ADDENDUM# 1
FERNRIDGE PARK AQUATIC FACILITY RENOVATIONS
Bid # 6216F

July 20, 2011

The Contract Bidding Documents pursuant to Bid # 6216F are hereby revised as follows:

SPSK
02
ENLARGED PLAN

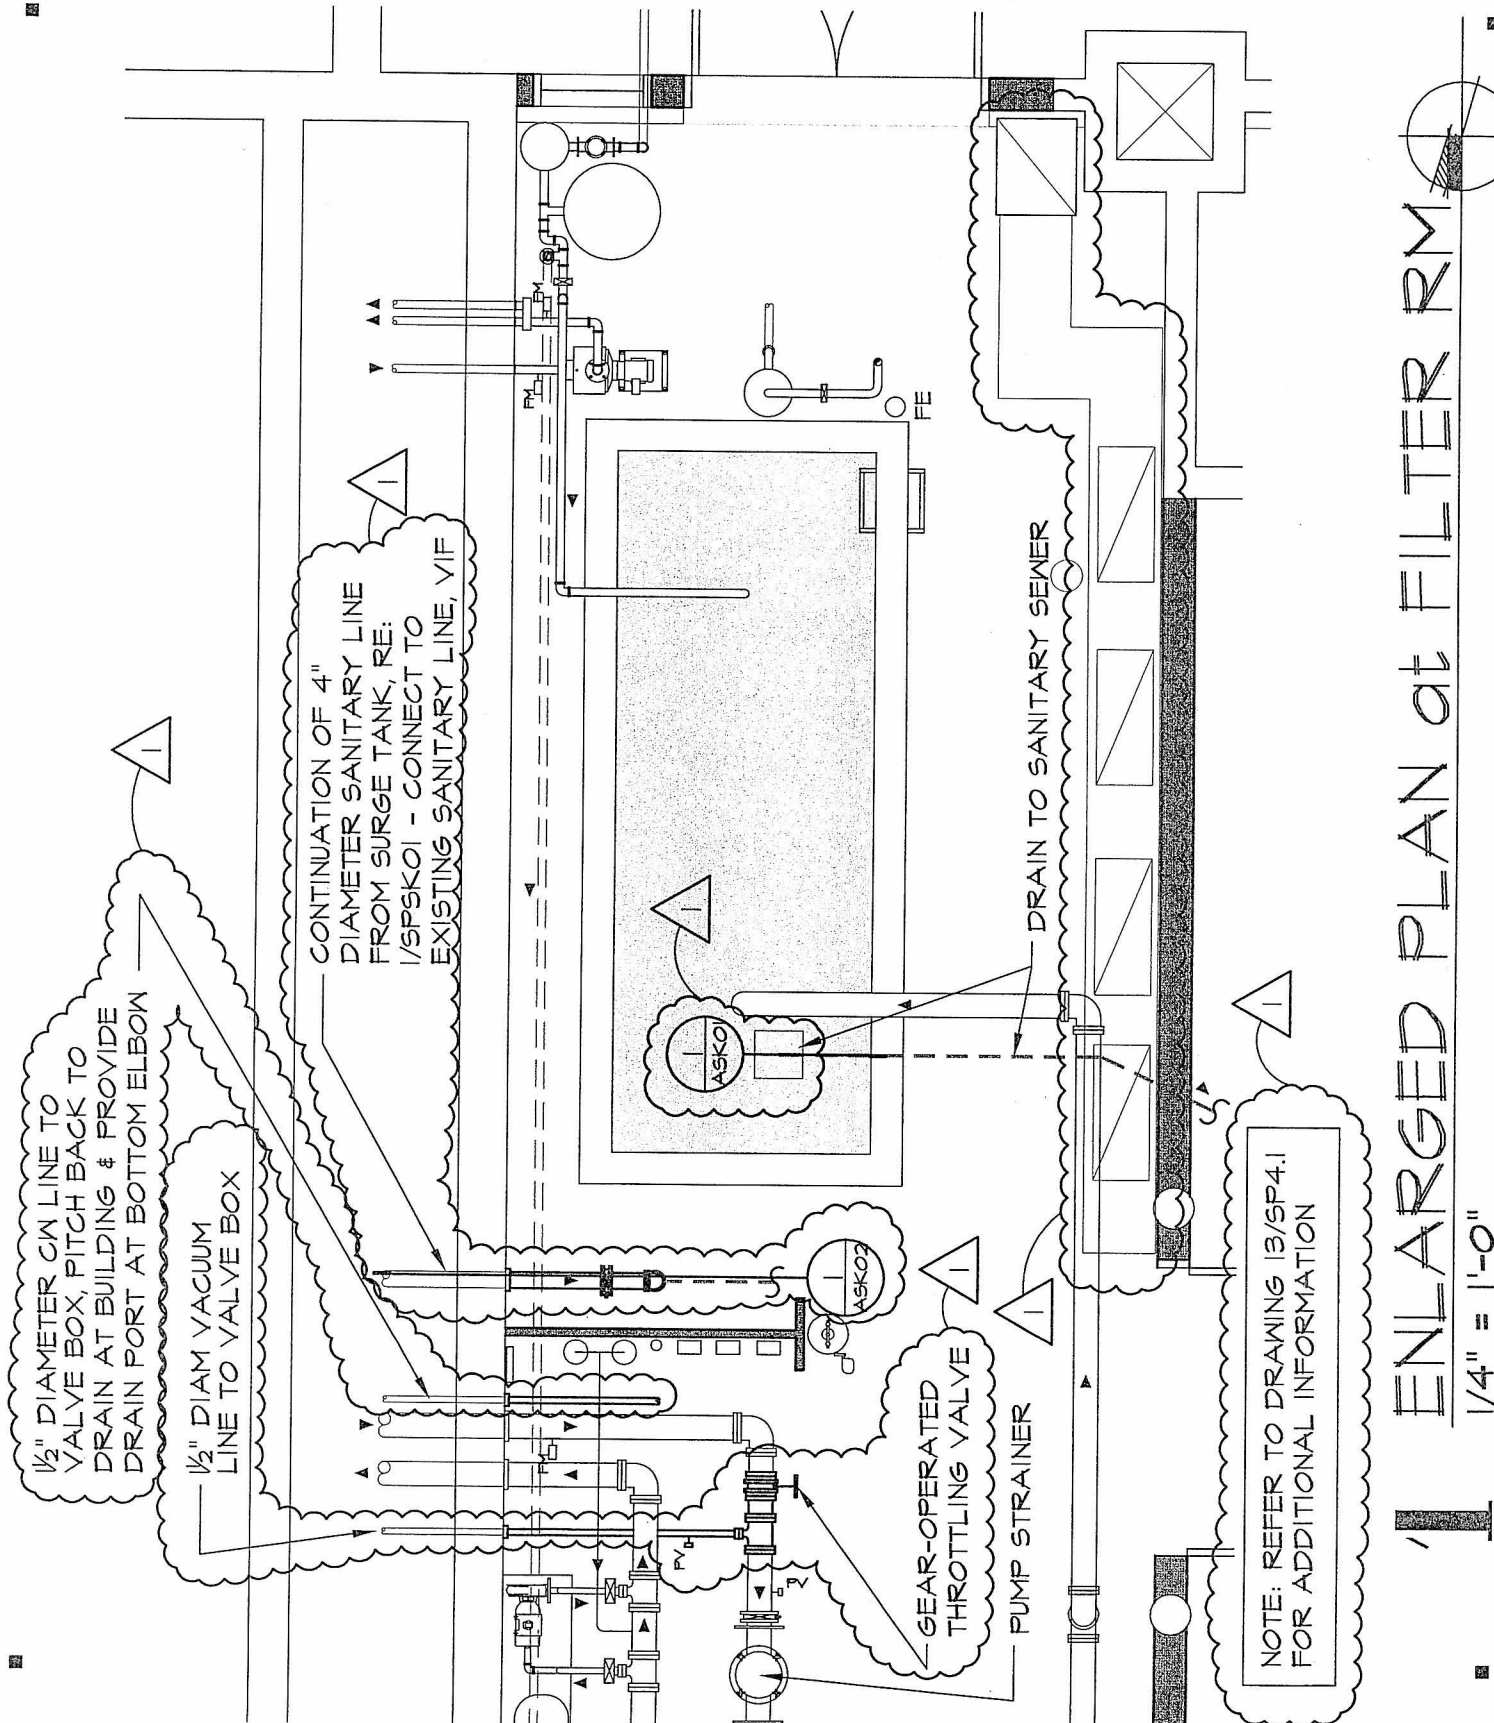
- Add:* Vacuum line shall run into Filter Room 01, instead of into Surge Tank, and shall connect to suction side of pump, with valve and gauge, as indicated in details noted below.

- Add:* Provide 1 1/2" water line from 1 1/2" water line in Filter Room 01, below Auto-Fill to recessed Vacuum / Fill Box at Pool Deck. Provide quick connect coupling and fill funnel.

- Add:* SPSK 02 "Enlarged Plan at Filter Room" and SPSK 03 "Section Detail at Deck Box / Fill Spout".
9. Drawing SP 3.1
- Modification:* Provide 'tee' fitting, piping, reducers and valves as required to allow pool to gravity drain to sanitary sewer with a connection within Filter Room 01.

SSTL. FILL SPOUT EQUAL TO
LINCOLN #40-110 (1/2") WITH
QUICK-DISCONNECT COUPLING -
PIPE TO 1/2" WATER LINE AT
LOWER LEVEL, BELOW AUTO-FILL

1/2" VACUUM LINE WITH FITTING TO
SUCTION SIDE OF PUMP "P1" AND
PROVIDE GEAR OPERATED
THROTTLING VALVE, RE: ASK 04

ASK 01
DETAIL

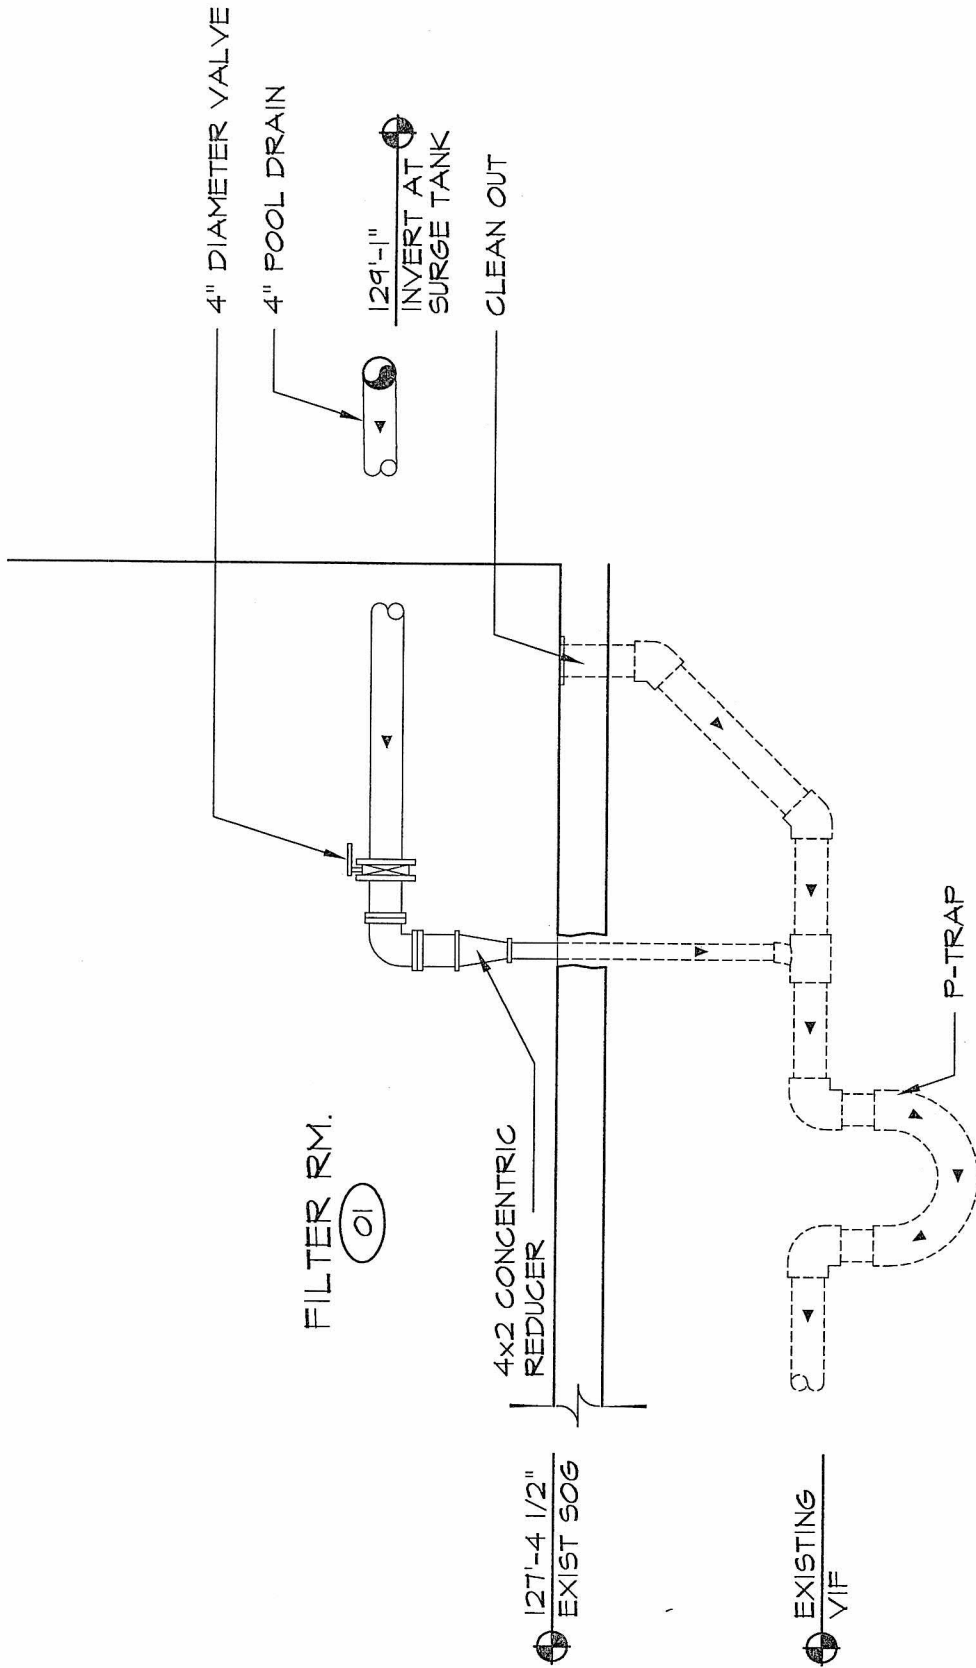
- Add:* SPSK 01, Plan Detail at Sump and ASK 02, Section Detail at Pool Drain.
10. Drawing SP 4.1
- Modification:* At Backwash Holding Tank, modify drain to allow a maximum of 100 GPM flow to Sanitary Sewer, per MDC requirements.

- Add:* ASK 01, Section Detail at Sump
11. Drawing M-001
- Modification:* Fan EF-1 shall be equal to Greenheck Model BSQ-100-3, 1280 CFM @ 0.5 TSP, 1/3 HP, 120/1/60. See Sketch SKM-1.

SKY-2
SHEET TITLE

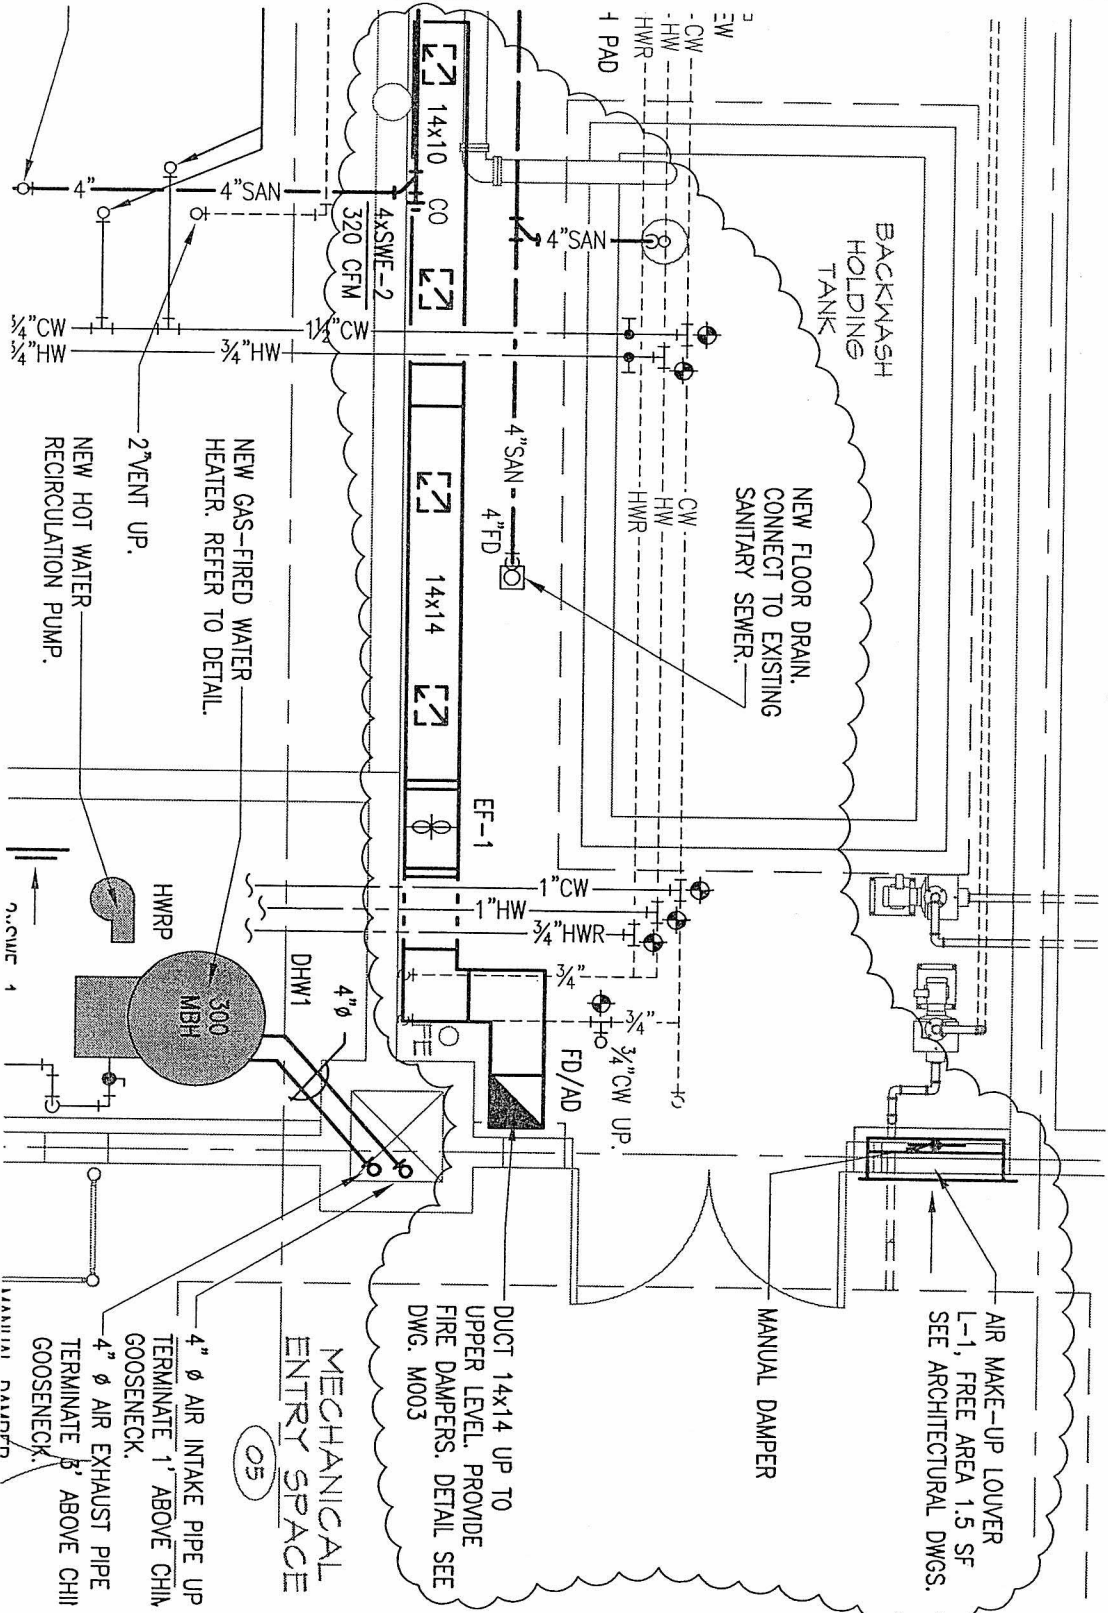
12. Drawing M-003,
- Modification:* Fan EF-1 shall be located in pool equipment room. See revised ductwork plan sketch SKM-2.
13. Drawing M-2.1
- Modification:* Modify exhaust, makeup louvers system EF-1 and intake and exhaust pipe for new gas-fired water heater - see sketches SKM-3.

REF. DRAWING M-2.2

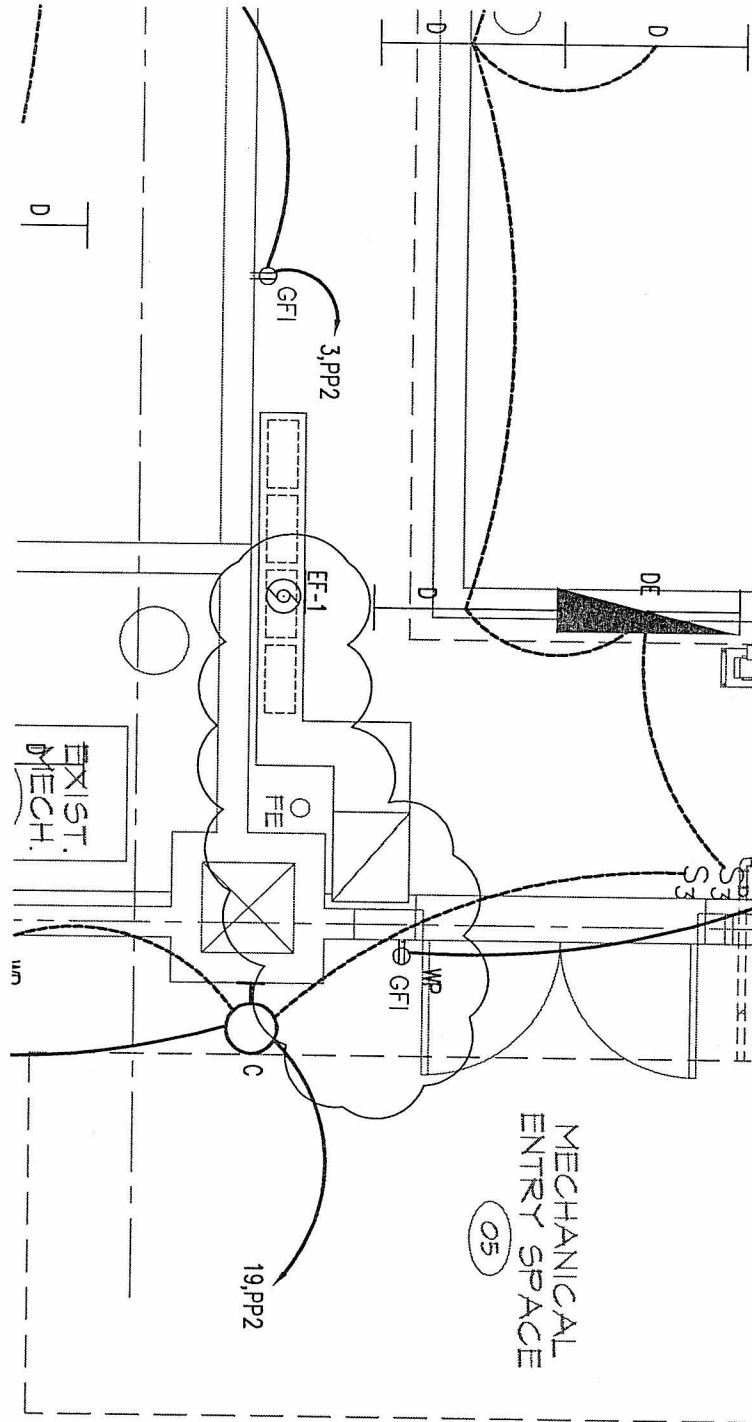
14. Drawing M-2.2
- Modification:* Modified exhaust, makeup louvers system EF-1 and intake and exhaust pipe for new gas-fired water heater -see sketch SKM-4.
